## Addendum 1

Request for Quotation Addendum 1 - 5330-02-1030 – Fire Hall No 3 Roof Replacement.

**Site Pictures.**

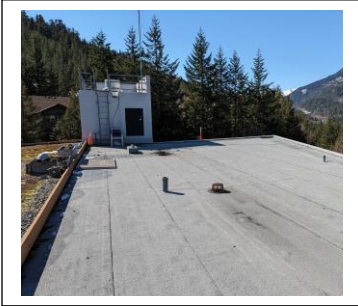
**4, Q.** Do you have existing photos of said roof areas to be replaced so that we can see their overall current condition.

**A.** Please see the site pictures below.
